Design Hazard Review: DSRP Bench Unit

SLIPSTREAM PILOT TEST UNITS FOR DIRECT SULFUR RECOVERY PROCESS AND ADVANCED HOT GAS PROCESS

August 2000

DSRP FIELD TEST PILOT UNIT P&ID - SIM ROG SYSTEM Direct Sulfur Recovery Process Wilsonville, AL	DOE-FETC	DWG. NO. PID0010
--	----------	------------------

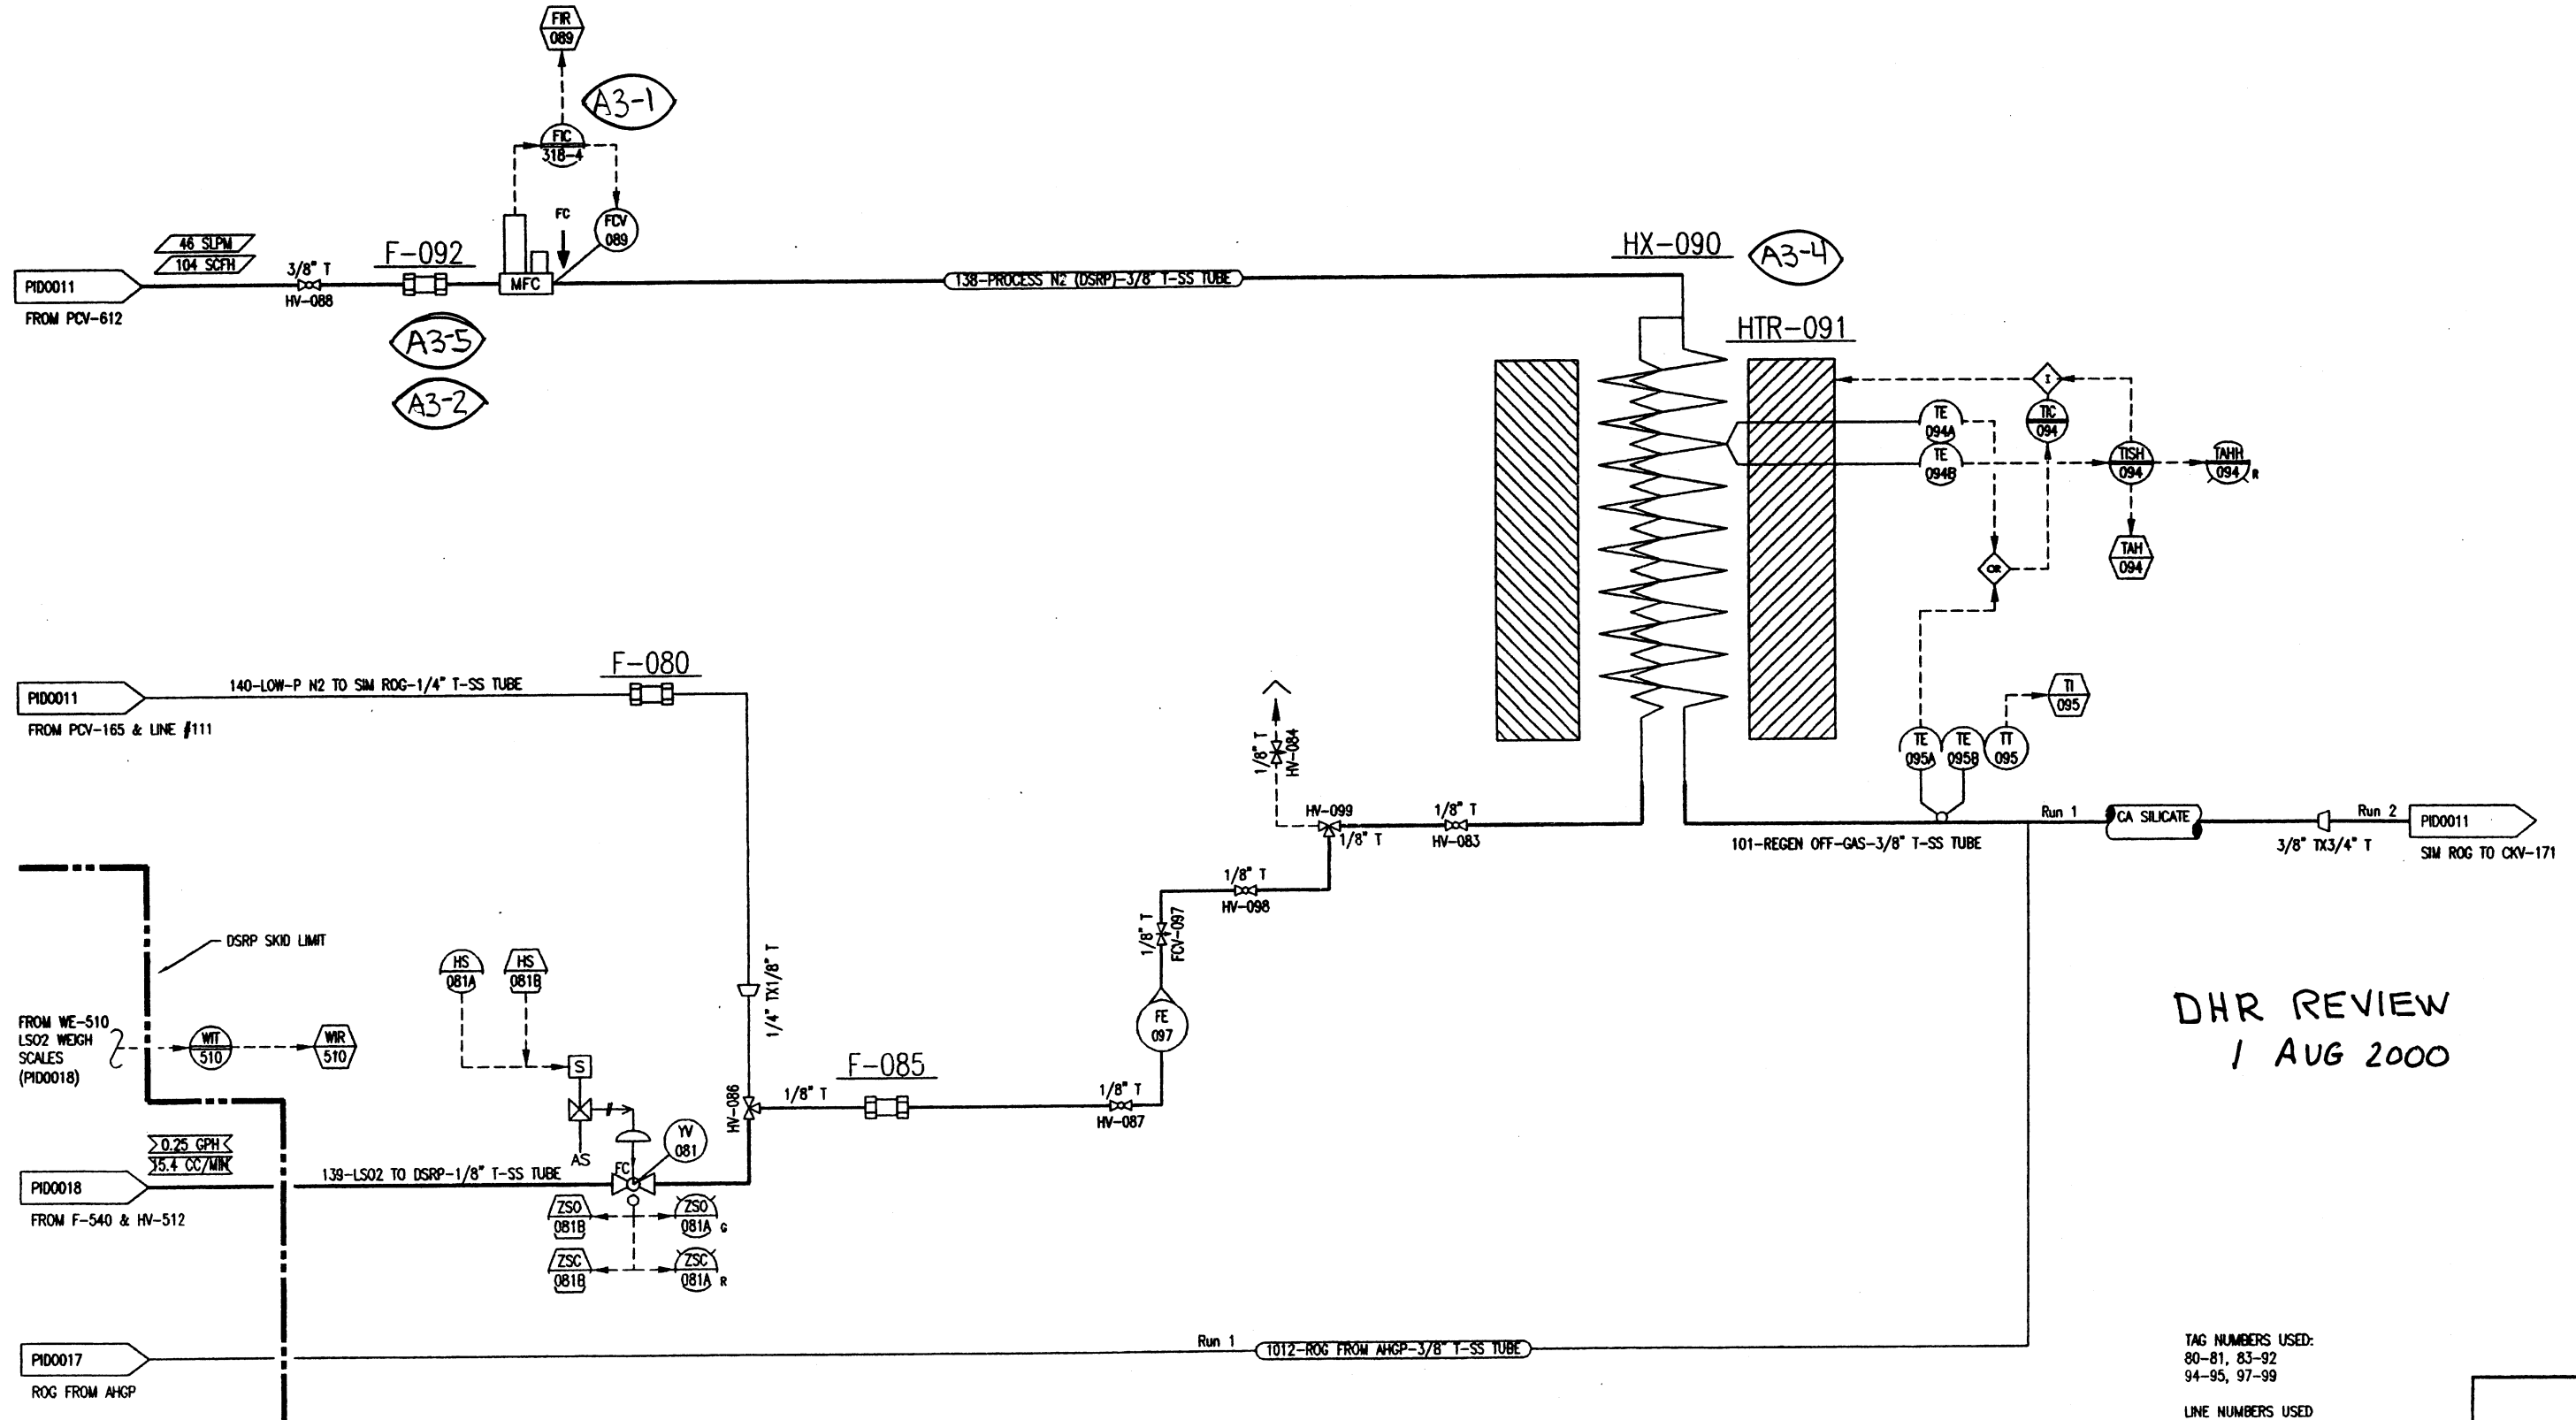
A3-5	PID-0010 FE-097	Reverse flow during online clean out of FE-097 with low pressure N ₂ .	H-086 3-way valve fails.	O-LSO ₂ back flow into low-pressure nitrogen purge line 140.	None.	Consider adding check valve in low-pressure nitrogen line to HV-086.	RTI

DHR REVIEW
 31 JULY 2000
 1 AUG 2000
 2 AUG 2000
 3 AUG 2000

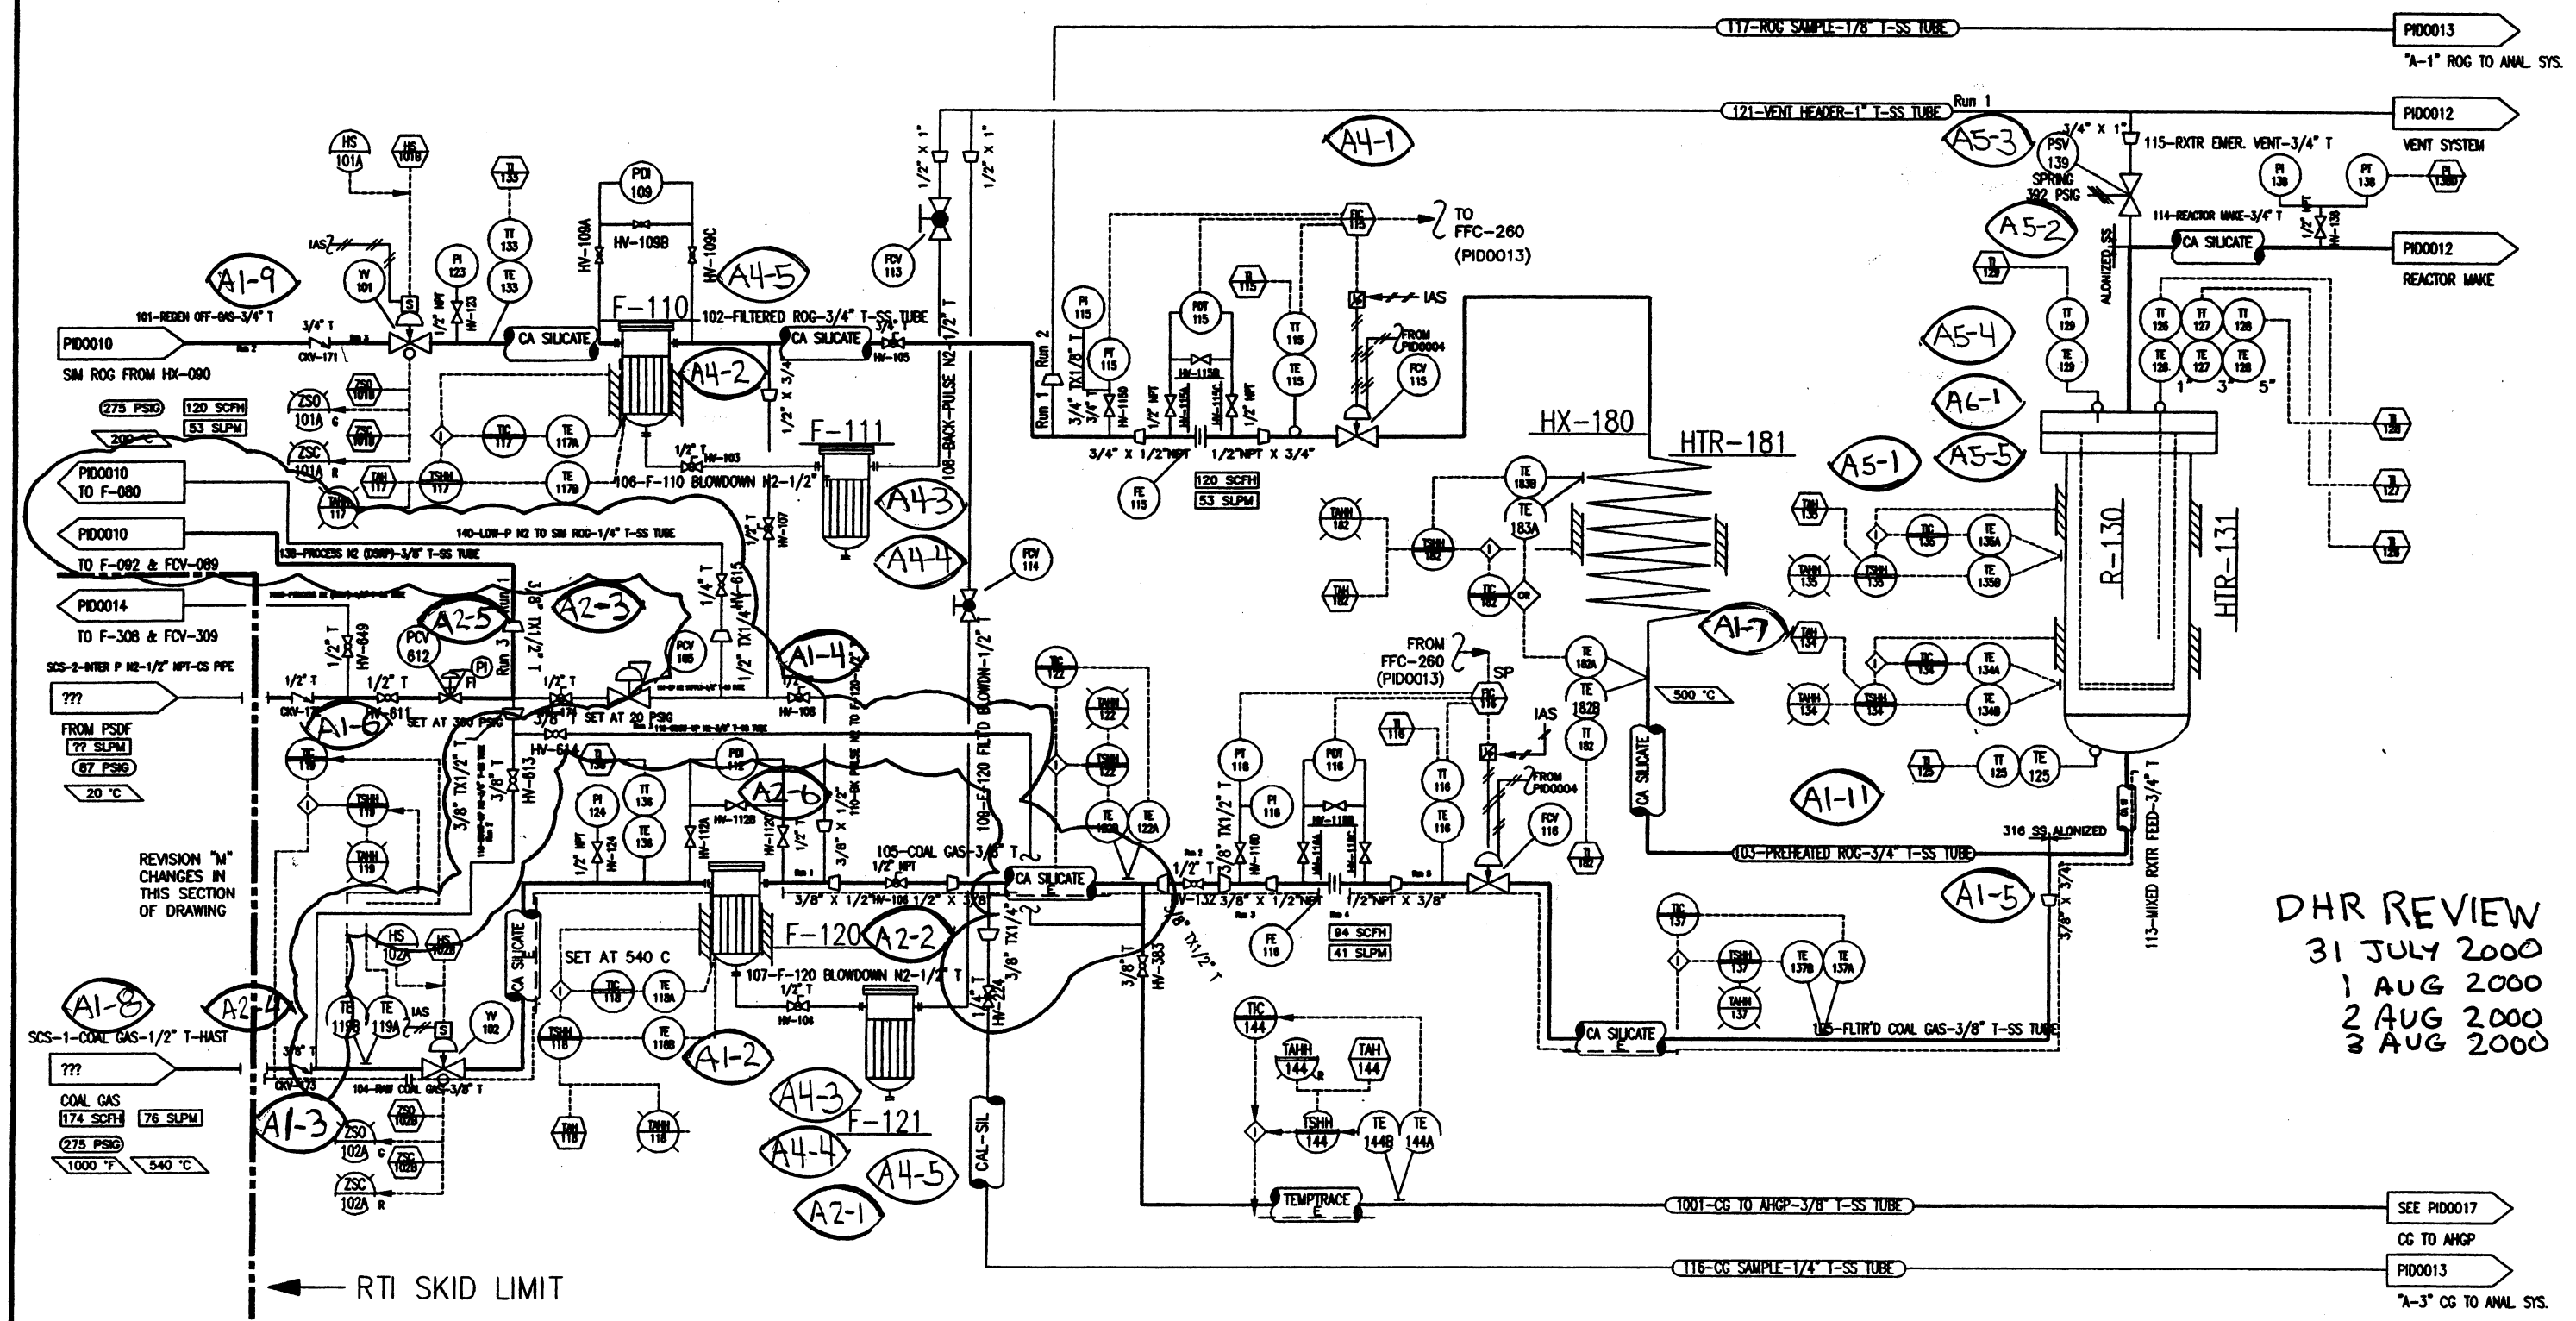
A1-3	PID-0011 CKV-173	Reverse flow via CKV-173	KBR transport reactor depressurizes rapidly without notification to DSRP operators.	<ul style="list-style-type: none"> O-Potential damage to CKV-173 resulting in emergency S/D with forced venting and possible line blowout. 	None	Provide computer pressure signal from transport reactor pressure to RTI/DSRP PC for monitoring and trending.	SCS	
A1-4	PID-0011 PDI-0010	Misdirected flow from coal gas line to low pressure nitrogen line via HV-108.	Operator inadvertently leaves or adjusts HV-108 in open position following F-120 filter blowback cycle.	<ul style="list-style-type: none"> O-Potential for contaminating low-pressure nitrogen line. Contaminating SIMROG rotameter FE-097 during purge cycle. 	Procedure	Confirm procedure provides precautionary action plan to prevent event occurrence.	RTI	
A1-5	PID-0011 Line 103	Misdirected flow from coal gas line into SIMROG system via HX-180 outlet line.	SCS/RTI operator inadvertently closes isolation valve on LP nitrogen supply to RTI and CKV-171 fails to open.	<ul style="list-style-type: none"> O-Potential for contaminating SIMROG supply system to R-130. 	<ul style="list-style-type: none"> Procedure CKV-171 	Consider carseal open manual valve at SCS tie-in connection and provide tagout procedure with RTI	SCS

A1-6	PID-0011 Drawing pressure/temperature notation for equipment	High pressure From SCS.	<ul style="list-style-type: none"> SCS nitrogen supply PCV fails. KBR transport reactor operation increased to 285 psig test conditions without notification. 	<ul style="list-style-type: none"> S-Potential to over pressure R-130 DSRP reactor. 	<ul style="list-style-type: none"> Equipment design parameters exceeds operating condition. PCV-612 PI measurements Operator intervention 	<ul style="list-style-type: none"> Provide proper-drawing notations to clarify noted parameters. Confirm tubing, piping, and vessel design meets or exceeds API B31.3 petroleum piping requirements. 	RTI

A1-9	PID-0011 SO ₂ feed line to DSRP.	Leaks same as A1-8.	<ul style="list-style-type: none"> Connector leaks. Instrument leaks. Valve packing leaks. 	<ul style="list-style-type: none"> S-Potential for high SO₂ gas release. Operator exposure hazard. 		<ul style="list-style-type: none"> Pressure leak test prior to operation. Operator leak check monitoring. 	Install SO ₂ sensor behind heater control panel and integrating in RTI alarm/monitoring system with audible alarm capabilities.	RTI	
A1-10	PID-0011 Line DSRP-OG-1/2	Leaks same as A1-8.	<ul style="list-style-type: none"> Flange leaks. Connector leaks. Valve packing leaks. 	<ul style="list-style-type: none"> S-Potential for high toxic gas (>2000ppm H₂S) release. Personnel/operator exposure hazard. 		<ul style="list-style-type: none"> Pressure leak test, prior to operation. Operator leak check monitoring. 	Install H ₂ S sensor located above V-150 sulfur separator pot.	RTI	(refer to B2-2)

A1-11	PID-0011 Vessel and line heaters.	Power loss local failure.	Circuit trips and auto resets.	S-Potential for high temperature equipment damage by overheating.		Design configured for heaters to latch in "off" mode on power failure.	Review and confirm heater latching "off" on power loss meets operating requirements.	RTI	
A1-12	PID-0011 F-110 CKV-171 YV-101	High pressure. Equipment pressure/temperature ratings.	Existing procured equipment incompatible with the new process operating conditions.	S-Potential for equipment overpressure damage and personnel injury.			Review existing equipment for MAWP/temperature ratings and verify compatibility with process operating conditions.	RTI

A2-3	PID-0011 F-120 Filter PCV-612	High pressure in F-120 from SCS nitrogen supplies.	PCV-612 and PCV-165 fail.	<ul style="list-style-type: none"> O-Potential for filter element damage. Potential for overpressure equipment vessels. 	Low probability of failure for two regulators in series.	<ul style="list-style-type: none"> Review and determine pressure conditions in event of PCV-612 and PCV-165 failure. Determine MAWP for equipment and develop PSV-139 set pressure based on limiting equipment. 	RTI	
A2-4	PID-0011 Line 118 nitrogen startup line to coal gas Line 104.	Startup.	Backflow of coal gas into nitrogen purge line up to HV-613.	O-Potential for acid condensation in cold dead leg.	None.	In developing startup procedure, consider opening coal gas supply valve into higher-pressure nitrogen flow before closing HV-163.	RTI	
A2-5	PID-0011 PCV-612 nitrogen supply line.	Low flow during nitrogen startup flow demand.	PCV-612 undersized to flow required capacity.	O-Potential to limit startup pressure and flow requirements.	N/A	<ul style="list-style-type: none"> Verify PCV-612 sized to meet requirements for startup demand. Consider adding upstream pressure indicator for PCV-612 nitrogen regulator. 	RTI

A2-6	PID-0011 Nitrogen startup and backpulse lines.	Low temperature contaminants.	Uninsulated lines between heated lines and nitrogen block valves.	O-Potential for purge lines to plug with tar and corrode from formed acid condensibles.	None.	Consider adding check valve similar to CKV-173 at branch connection if problem occurs.	RTI

A4-3	PID-0011 F-110 F-111 F-121	Maintenance offline cleaning of filter.	F-110 plugs and requires offline cleaning.	S-Personnel exposure hazard. Sudden pressure release when opening fills to replace filter element.	Operator procedure.	Consider adding vent, PI, at F-111 and F-121 filters to confirm depressurized condition acceptable for filter element removal. Consider changing P&IDs to depressurize filters to a low-pressure vent header (see V-188 study reference notes).	RTI	
A4-4	Same as A4-3	Same as A4-3	Same as A4-3	S-Potential handling and disposal hazard.	Unknown.	Confirm storage/disposal requirements of filter media at PSDF.	SCS	
A4-5	PID-0011 F-110 F-120	High temperature shutdown.	Heater element hot spot and/or failures.	S-Equipment overpressure damage at operating temperatures.	High temperature cutout switch TSHH-117.	Confirm temperature S/D conditions and maximum allowable operating temperature of F-110 and F-120 is consistent.	RTI

A5-2	PID-0011 R-130	Low temperature in feed and off-gas lines.	<ul style="list-style-type: none"> Loss of heating. High heat loss. 	<ul style="list-style-type: none"> O-Unable to initiate reaction (below 500°C). O-Potential to condense sulfur (approximately 200°C). Sulfur solidifies at 130°C. O-Potential for S/D corrosion products to condense. S-Potential equipment damage. Potential for personnel injury. 	<ul style="list-style-type: none"> Heaters capable to preheat mixed feed and off-gas line to 999°F (537°C). Reactor vessel and process lines insulated. Feed and off-gas lines alonized. 	<ul style="list-style-type: none"> Review requirements and status for alonizing feed and off-gas lines for R-130. 	RTI	
A5-3	PID-0011 R-130	High-pressure. R-130 vessel overpressure.	<ul style="list-style-type: none"> Relief line plugs and PSV-139 fails to open. Relief line hot insulated. 	<ul style="list-style-type: none"> S-Potential equipment damage. Potential for personnel injury. 	<ul style="list-style-type: none"> PSV-139 set at 392 psig (MAWP of vessel 350 psig). 	<ul style="list-style-type: none"> Confirm release pressure of PSV-139 and readjust as required. Consider moving overpressure protection to upstream location. Move PSV-139 or install new PSV downstream of PCV-612 in nitrogen supply to process. 	RTI

A5-5	PID-0011 R-130	<ul style="list-style-type: none"> Low pressure. Startup, process upset, or off-design pressure operation. 	<ul style="list-style-type: none"> • Low pressure process operation. • Shutdown sequence. • Startup 	<ul style="list-style-type: none"> • O-Potential for high-pressure velocity and catalyst carryover. • Potential for catalyst to plug downstream orifice in V-150. 		<ul style="list-style-type: none"> • Develop operating velocity and pressure limit to prevent catalyst carryover. 	RTI
